Permit of Authorization to Construct an On-Site Sewage Facility Permit Valid For One Year From Date Issued

Permit Number: 117991
Issued This Date: 11/07/2024
This permit is hereby given to: Joshua & Kimberley McConnico

Design Report
On-Site Sewage Facility
Aerobic Wastewater Treatment System
Utilizing Surface Spray Application

From: [Ritzen,Brenda](#)
To: [Bucky Smith](#)
Subject: RE: revised application for 117991
Date: Wednesday, November 6, 2024 3:24:00 PM
Attachments: [Page from 117991.pdf](#)
[image001.png](#)

revised site plan

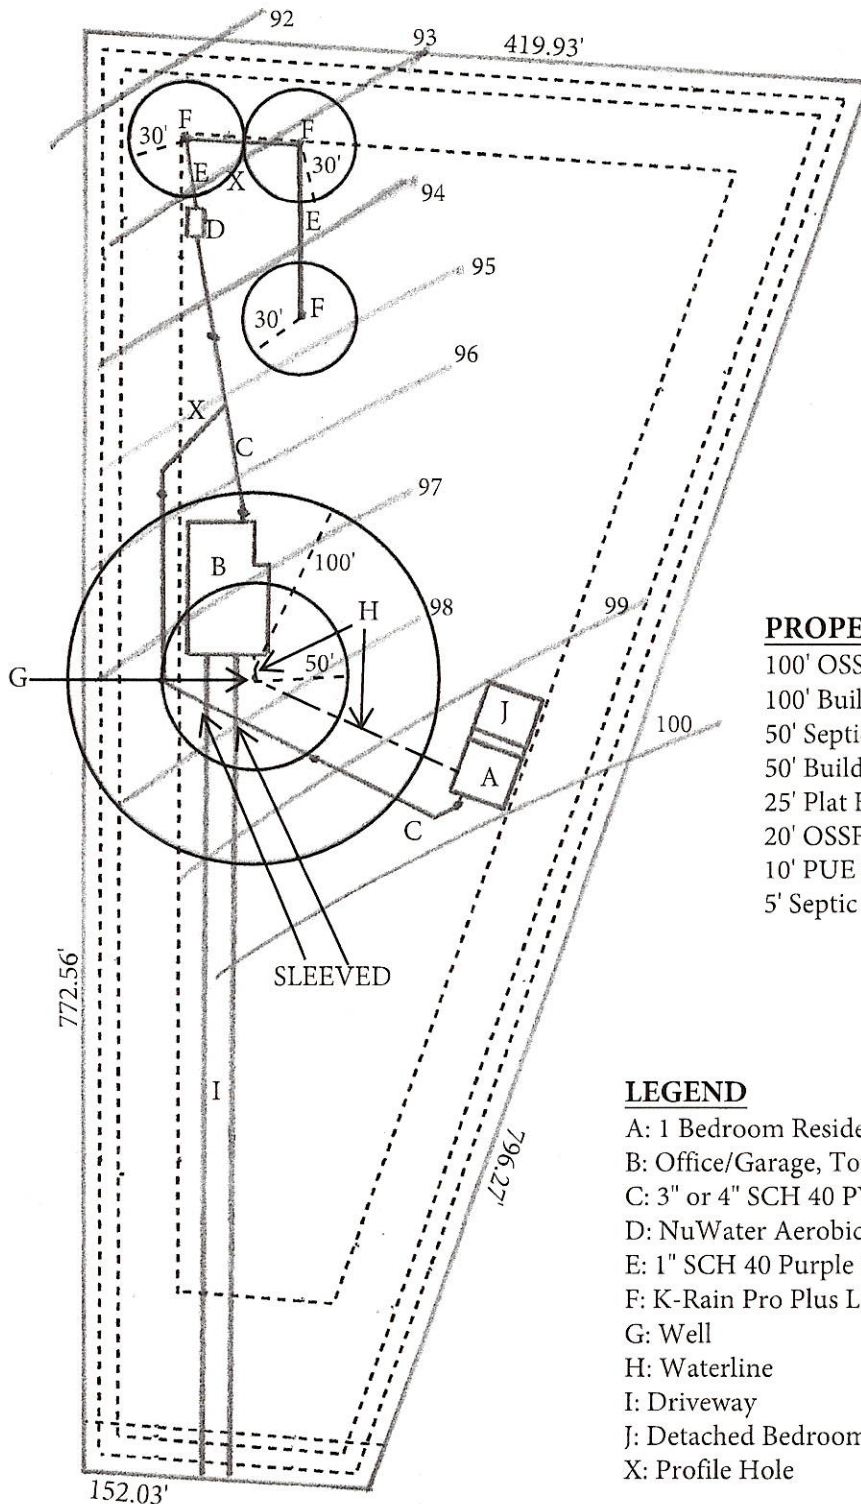
✓ The attached is the current design within the permit. Please revise the design to match your description of the structures indicated on the permit application.

Josh McConnico
742 Vista Ridge
Canyon Lake, TX 78133

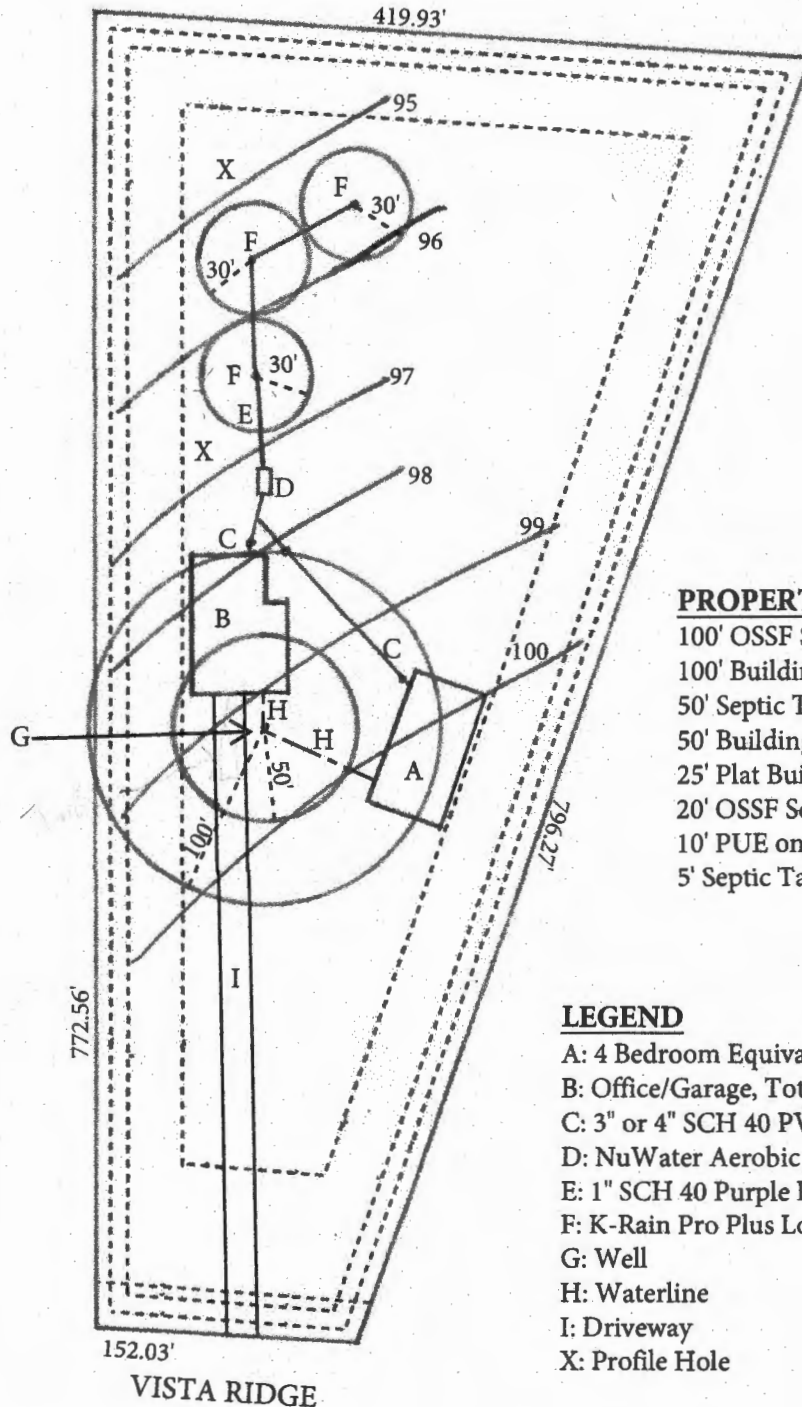
The permit application and written description of the structures do not match what is on the design. Also, the gpd indicated does not appear to meet TCEQ Table III requirements. All non-single family residential must indicate the type of use, number of people, etc. as applicable and follow Table III gpd requirements. Non-single family must also show the doubling area for the treatment and disposal system.
